# CONWAY

## CONWAY HISTORIC DISTRICT COMMISSION MEETING

OCTOBER 24, 2016 • 6:00PM • CITY HALL • 1201 OAK STREET

**OLD CONWAY DESIGN OVERLY DISTRICT  
CERTIFICATE OF APPROPRIATENESS  
YOUNG RESIDENTIAL ADDITION  
1224 WINFIELD STREET**

Site Plan

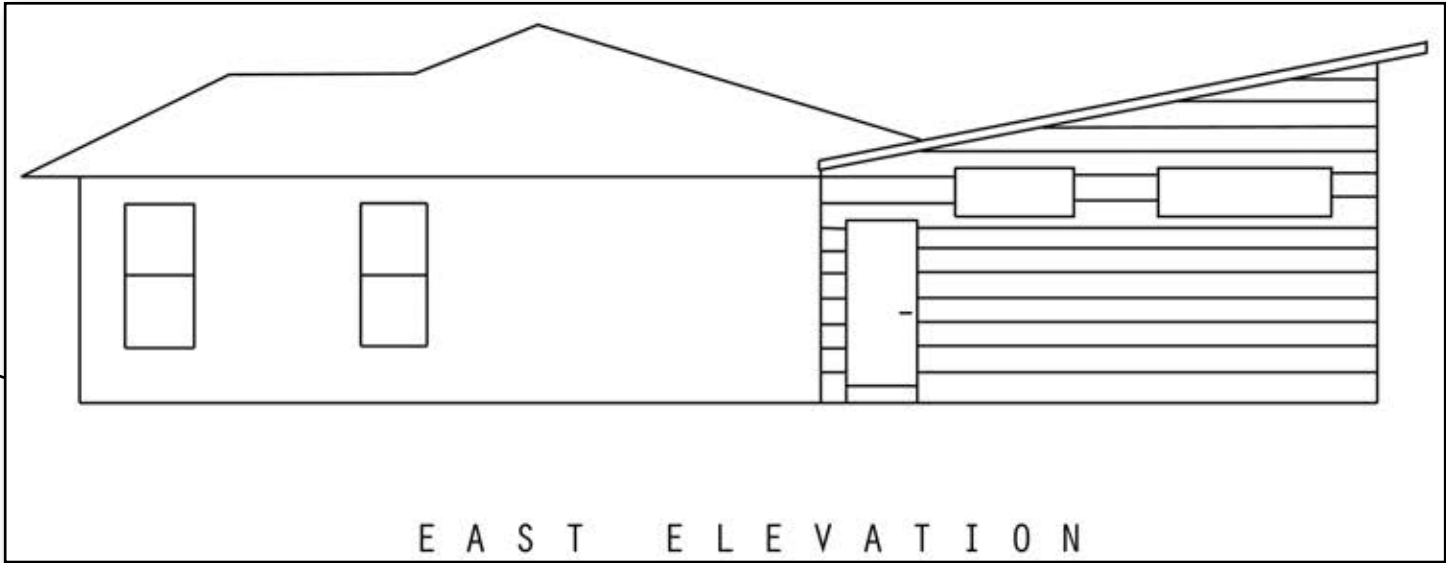
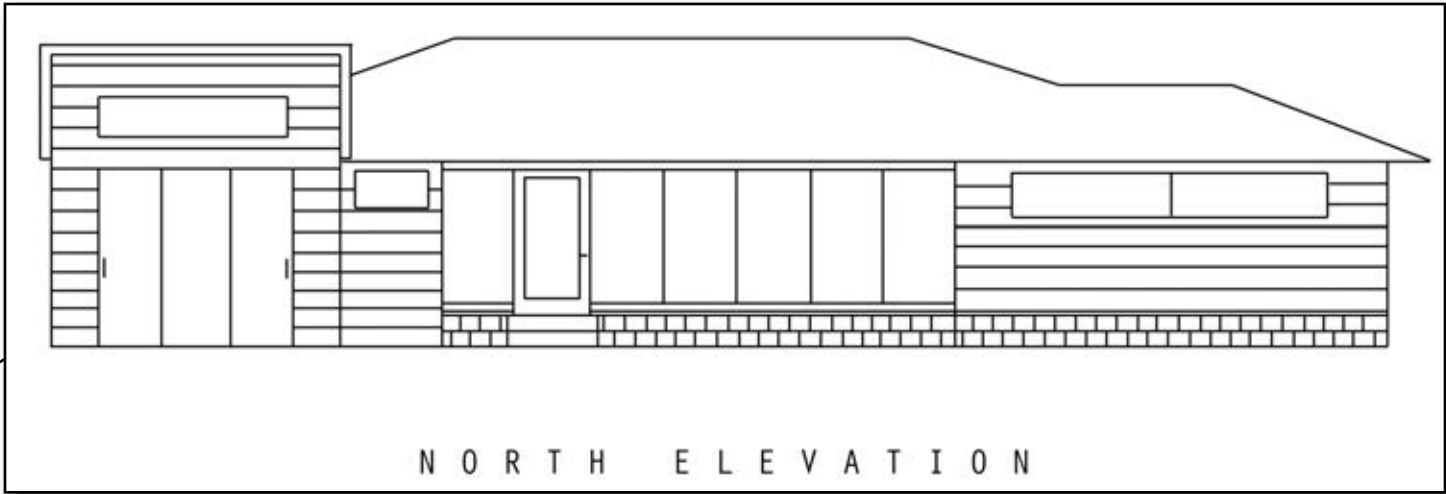
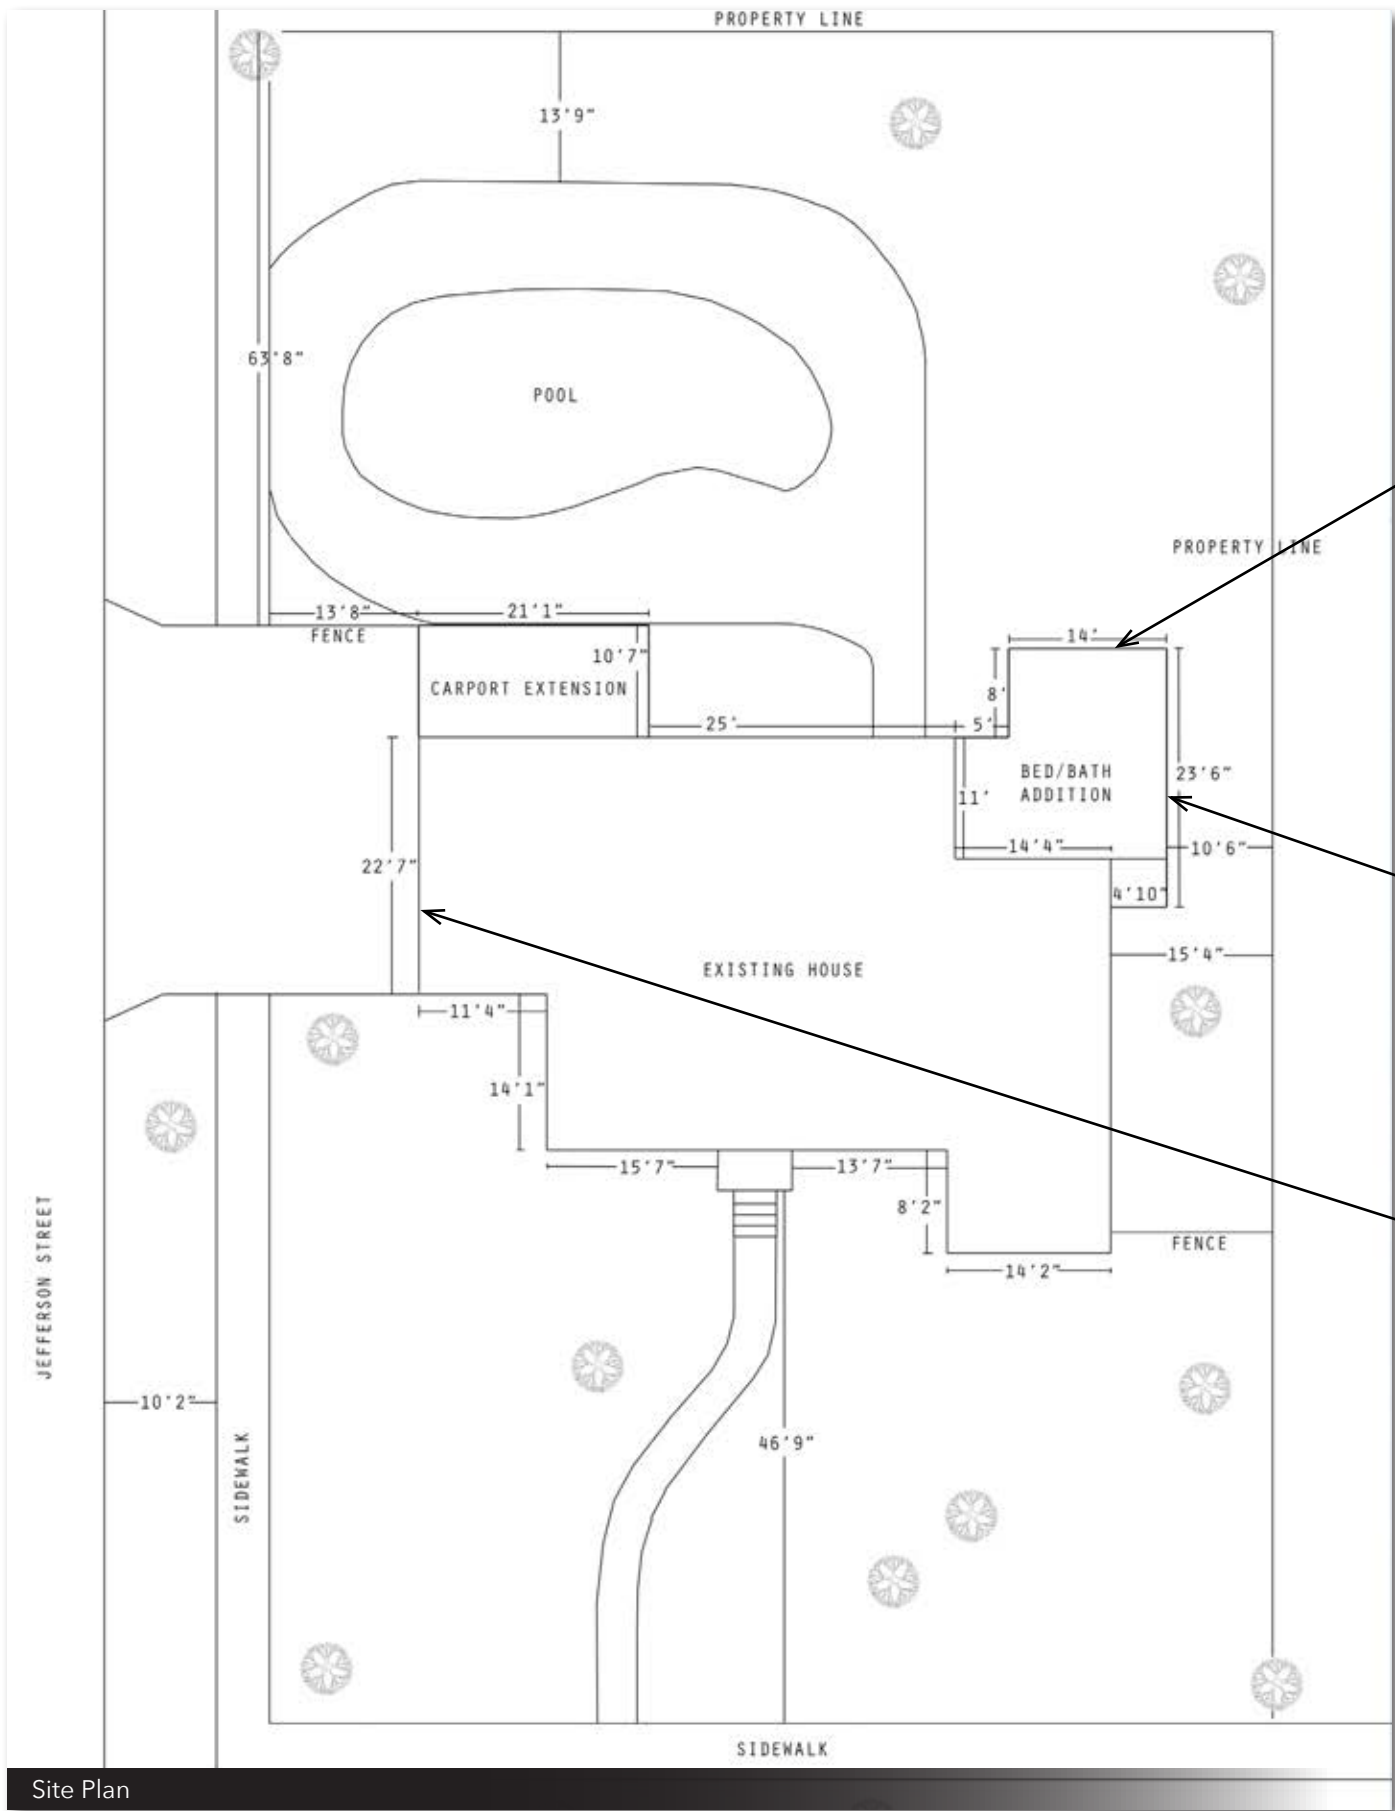
**Setbacks.** Proposed setbacks should respect the predominant setbacks of area structures, especially the front setback. Front setbacks are allowed within a range of 80% to 110% of the average area front setback. The front and west side setbacks will not be affected. The rear setback will be slightly reduced but will still have an ample rear setback of almost 64 feet. The east side setback is 10'-6". The rear and east setbacks are appropriate for the lot and neighborhood.

**Tree preservation.** It appears that a significant oak tree will be removed in order to expand the driveway. There appear to be ample trees on the property no remedial tree seems necessary.

**Height.** The average height of area structure's eaves and cornices. Also, the first floor elevation / height relationship. The addition will have a shed roof that will project no taller than the existing roof's peak. The addition will change the existing eave line however, it is larger unseen from the public realm. The carport extension will continue the existing eave line further north, but should not greatly affect the overall appearance of the west elevation.

**Architectural Details, Siding, and Bricks.** Eaves, brackets, dentils, cornices, molding, columns, trim, etc. The materials selected for a new dwelling should be compatible with and complement the surrounding structures in the Suburban Zone. Brick, stone, and wood are the most common and most appropriate materials for cladding and are strongly encouraged. Synthetic materials such as vinyl, aluminum, and synthetic stucco (EIFS products) are not historic cladding materials and should not be used. The existing residence is clad in a mid-century thin veneer sandstone. The addition would appear to have some form of lap siding. The proposed siding material is unknown. The applicant can provide more details about siding materials at the meeting.

Staff recommends approval of the addition, open carport, and driveway with the following conditions:

1. The addition, driveway, and carport extension shall be constructed as shown in submitted plans.
2. The addition will be clad with ? siding.
3. Roof shall be asphalt composition roof.

FLOOR PLAN

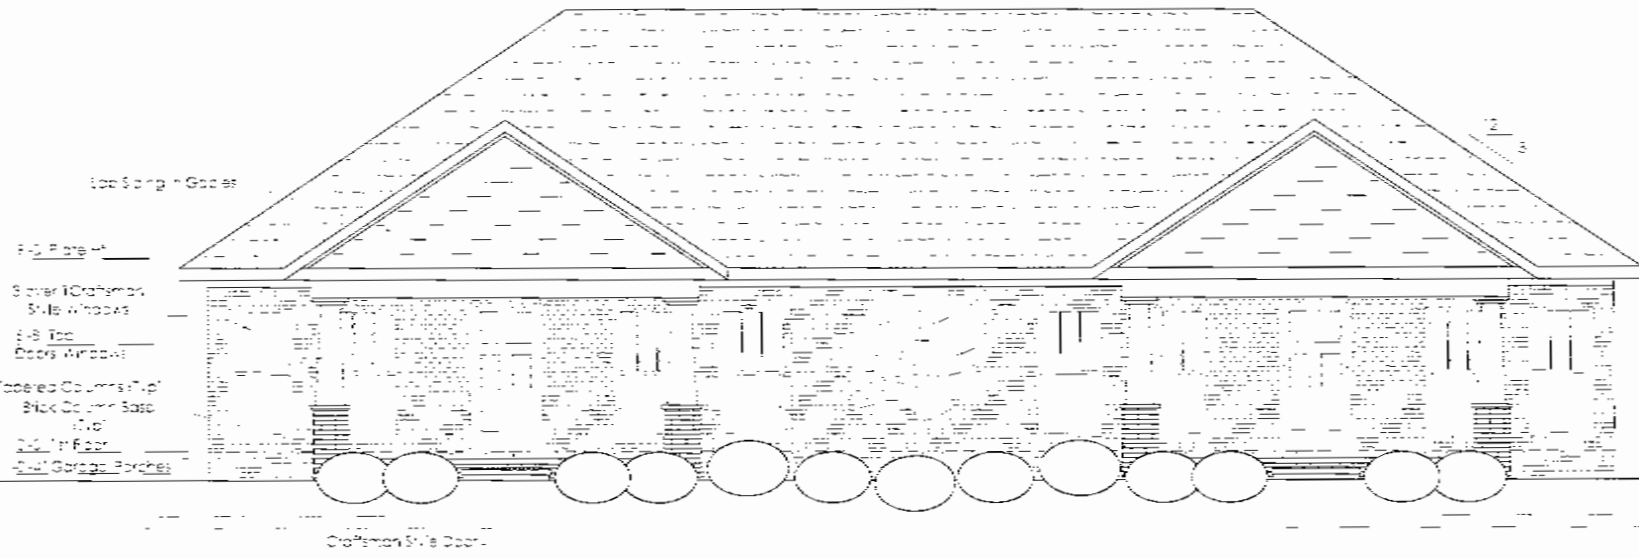
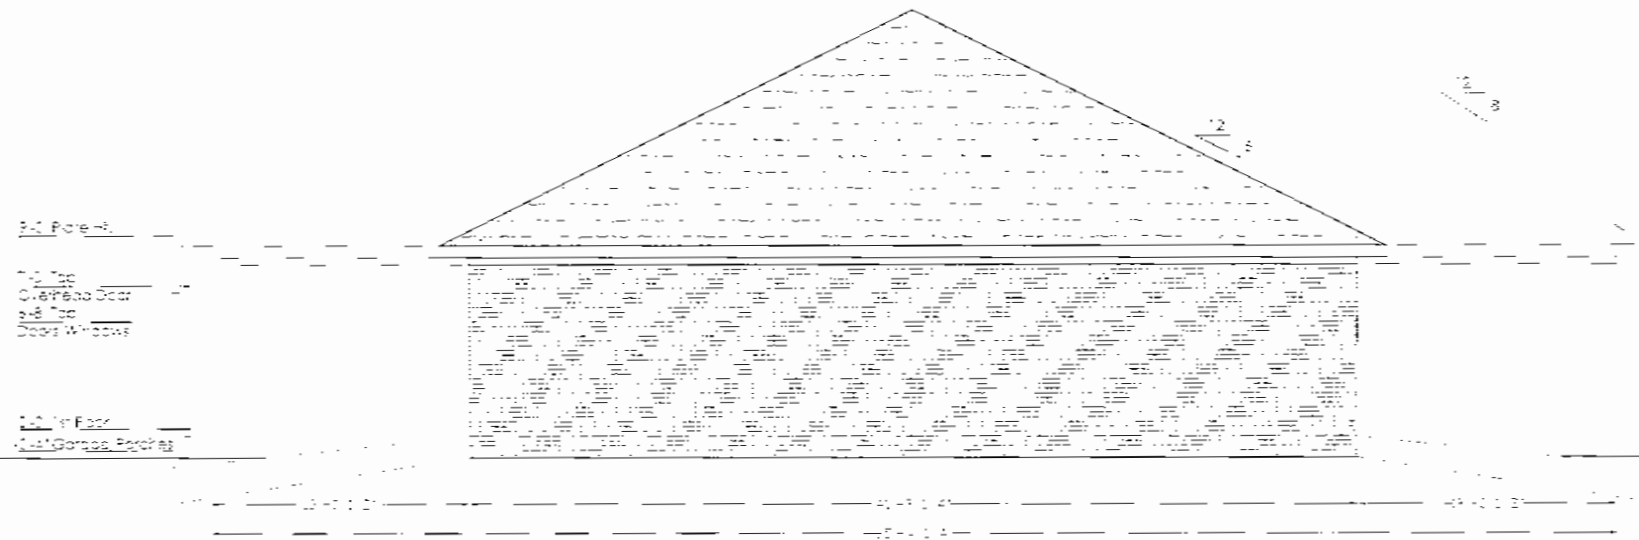
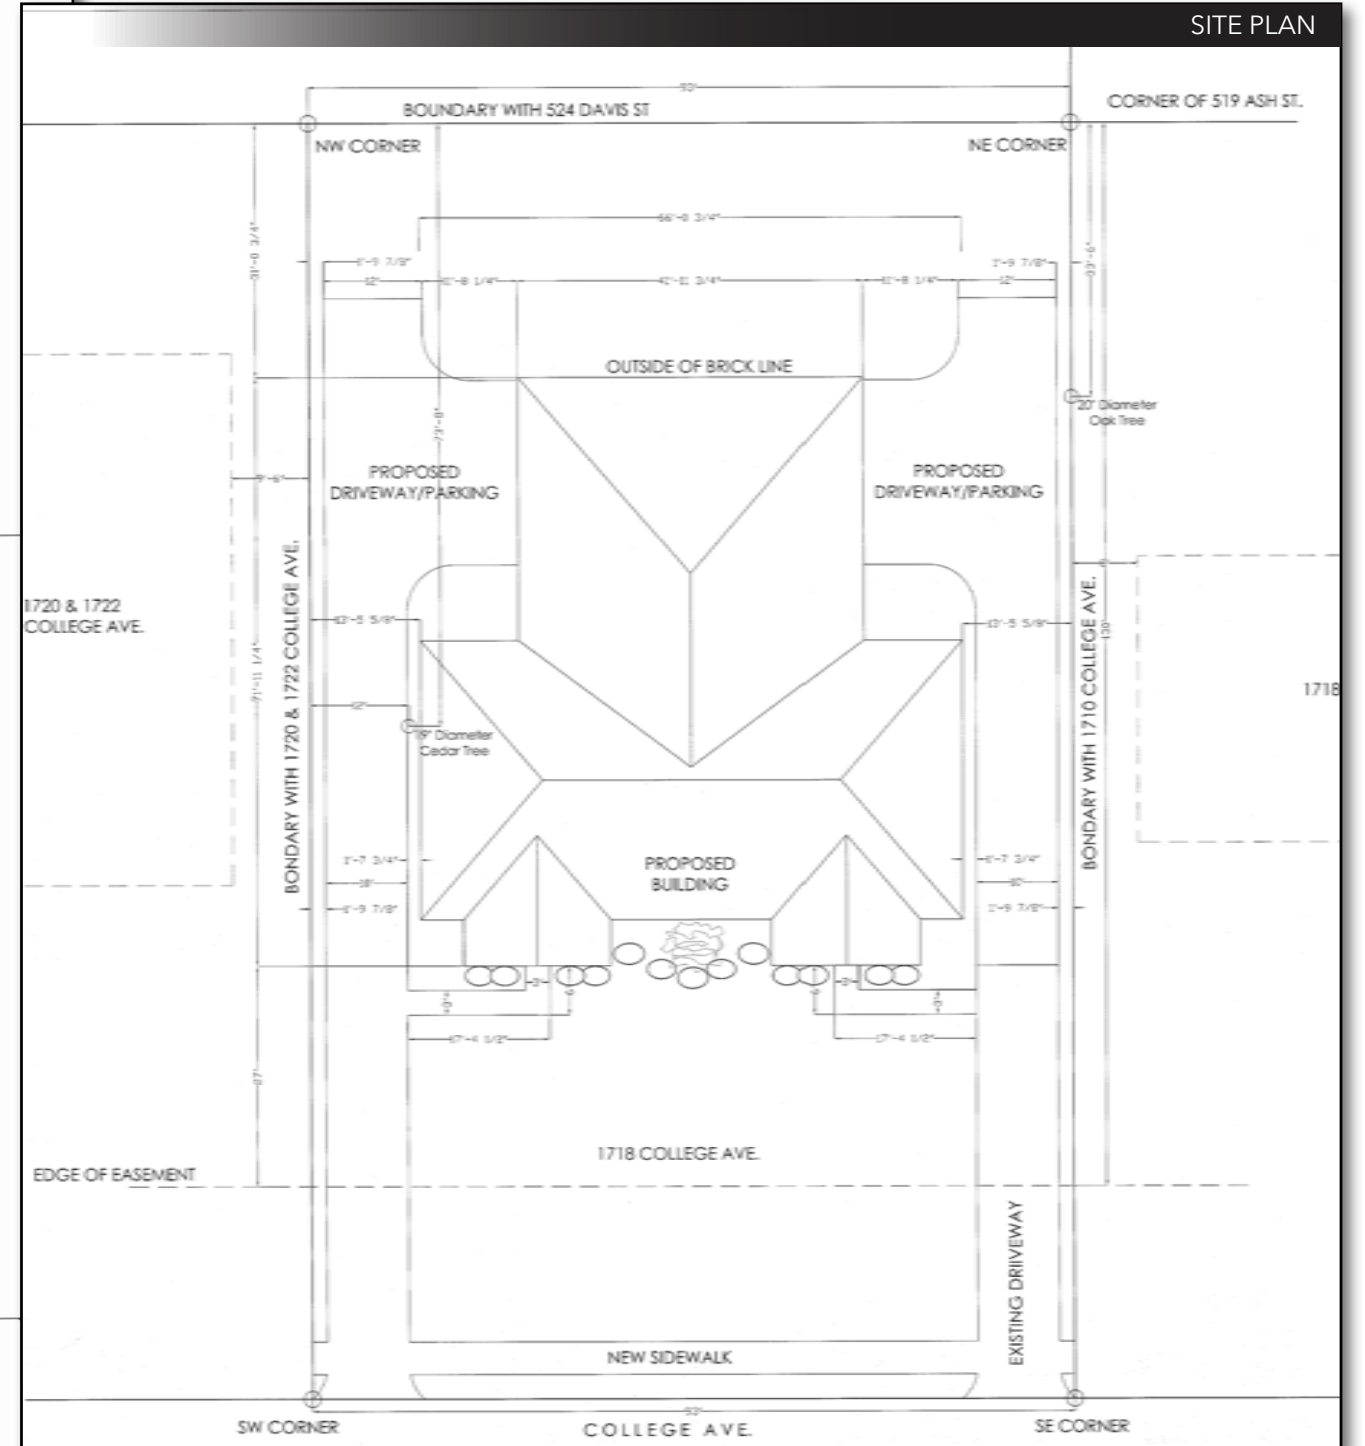
**Setbacks.** Proposed setbacks should respect the predominant setbacks of area structures, especially the front setback. Front setbacks are allowed within a range of 80% to 110% of the average area front setback. The average area front setback is 34 feet. The proposed 27 foot front setback is appropriate. The east and west side setbacks are 13'-5". The north rear setback is 31 feet. These setbacks are appropriate for the neighborhood.

**Tree preservation.** There is a 19" diameter cedar tree and a 20" oak tree that could be affected by construction. The cedar tree will need to be removed; the oak tree is centered on the adjacent east property line and may be sufficiently far away from new construction. A new 2" caliper tree should be planted in the front yard to remediate.

**Width.** New construction proportions shall respect the average widths of the majority of neighboring buildings in the area. Average area structure width is 47 feet. The new residence's width is 66 feet wide. The proposed width is larger than other area structures, however, the lot is wider than most area lots.

**Doors and windows.** The rhythm, patterns, and ratio of voids to solids of new buildings should relate to and be compatible with adjacent facades; typically a higher proportion of voids to wall area. The new residence has a large amount of windows on the front facade. The side elevations are slightly lacking in windows. These side elevations should have one window added to each side in the front bedrooms. The rear elevation is lacking in widows, but is unseen.

**Architectural Details, Siding, and Bricks.** Eaves, brackets, dentils, cornices, molding, columns, trim, etc. The materials selected for a new dwelling should be compatible with and complement the surrounding structures in the Suburban Zone. Brick, stone, and wood are the most common and most appropriate materials for cladding and are strongly encouraged. Synthetic materials such as vinyl, aluminum, and synthetic stucco (EIFS products) are not historic cladding materials and should not be used. Vinyl siding is discouraged. Wood, cement board, or brick are encouraged. The new residence is mostly clad in brick. Submitted plans list vinyl and metal to be used for trim and gables siding unless required otherwise.

Staff recommends approval of the addition, open carport, and driveway with the following conditions:

1. The residence and driveways shall be constructed as shown in submitted plans.
2. The residence will be clad with brick and ? siding. (Vinyl and metal are noted on the drawings for the trim and gables)
3. Two additional windows shall be added; one to the west elevation (front bedroom) and one to the east elevation (front bedroom).
4. Roof shall be asphalt composition roof.
5. A 2" caliper tree will be planted in the front yard to remediate the removal of a significant tree.
6. A 5 foot sidewalk is required along College Avenue or an in-lieu fee of \$1095.00 may be paid to the sidewalk fund. The sidewalk location should be coordinated with City Planning, Engineering, and Permits Departments.
